**TECHNICAL BULLETIN
No. 0126**

**Oil Cooler Plate
Heavy Duty K Transmission**

Figure A. Heavy Duty K Transmission with Oil Cooler Plate

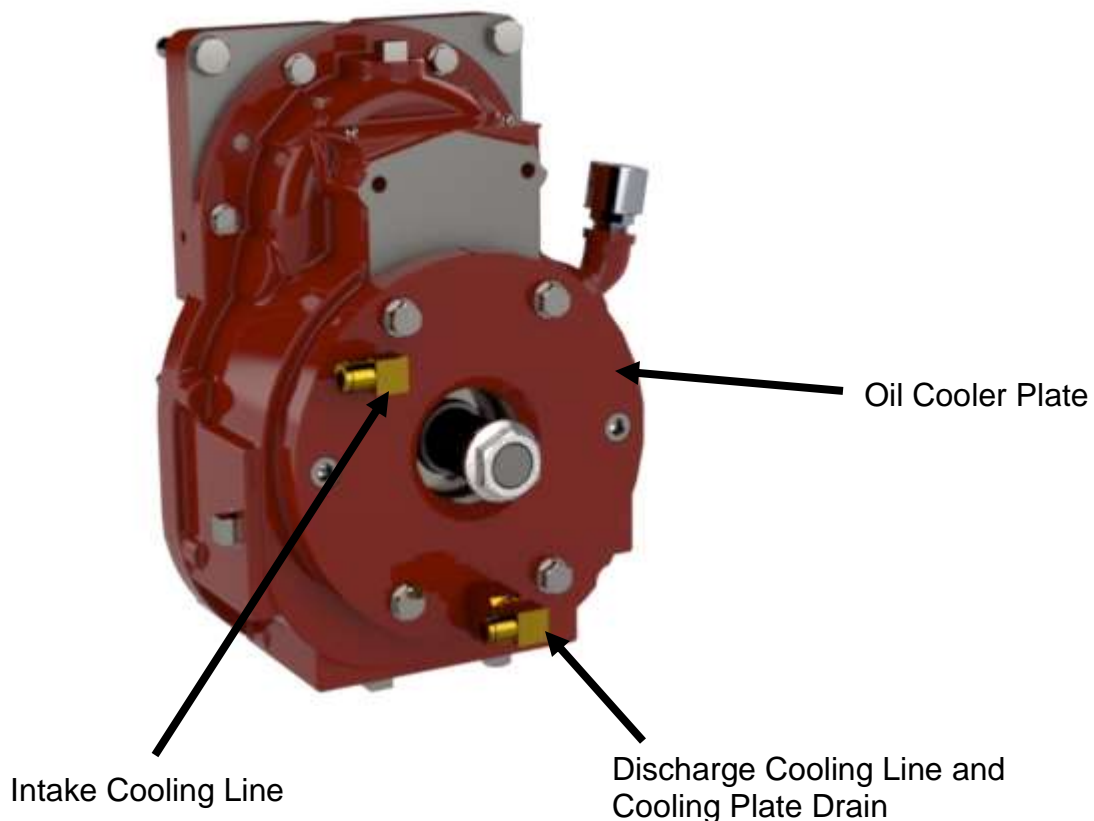
Waterous announces a new oil cooler plate on Heavy Duty K Transmissions (used on CM, CS, CG, CX and HL pumps).

Beginning on September 1, 2017, all orders received for Heavy Duty K Transmissions will have the new oil cooler plate unless equipped with hydraulic drive with SAE Class C input shaft.

- Oil cooler plate
- Intake and discharge cooling lines
- Drain plug on discharge cooling line to drain cooling plate.

Figure B. Dimensions of Heavy Duty K with Oil Cooler Plate

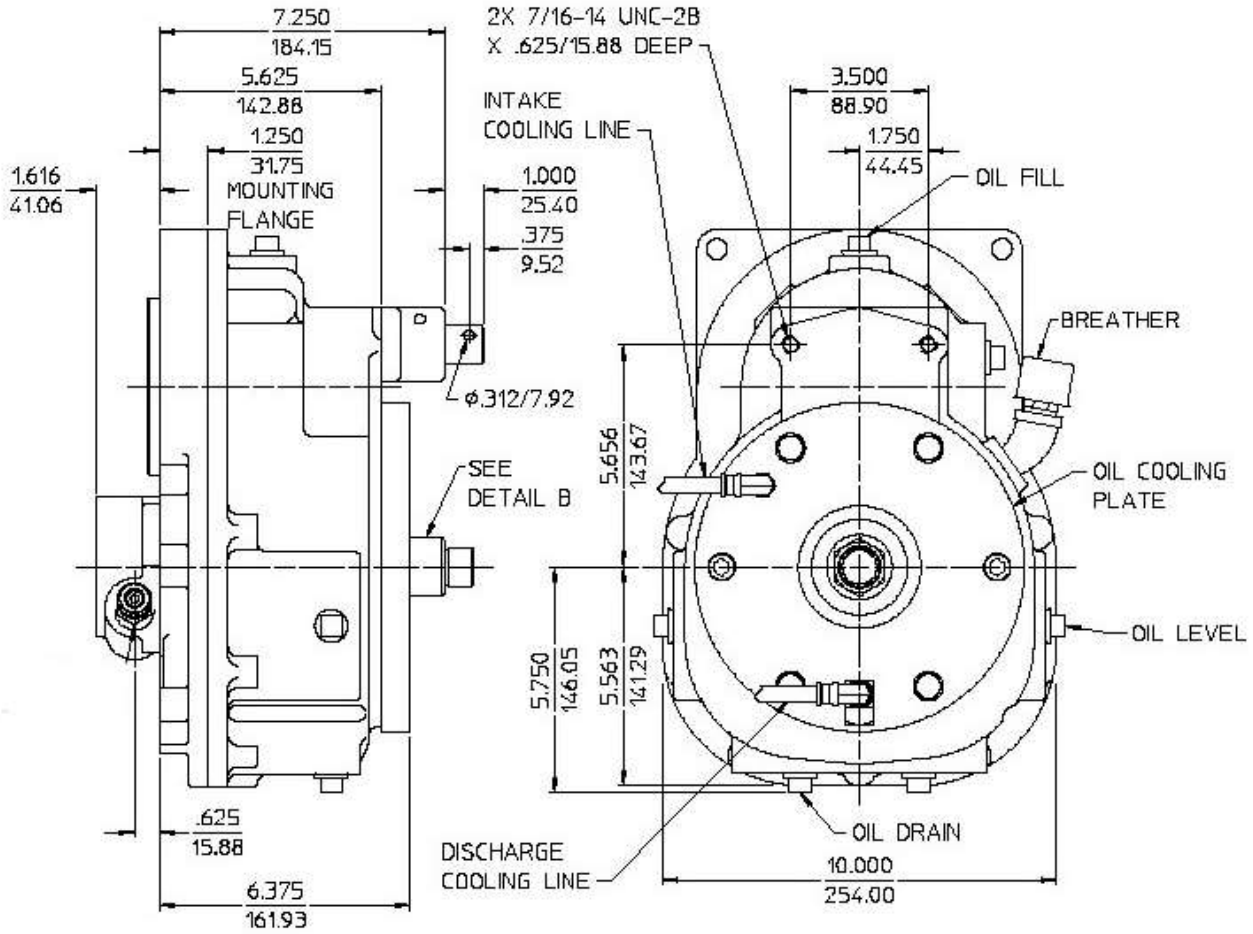
- Mounting: Avoid the cooling lines when fabricating mounting brackets.
- Cooling Line Sizes: 3/8" plastic tubing (factory installed).
- Figure B. Dimensions of Heavy Duty K with Oil Cooler Plate.
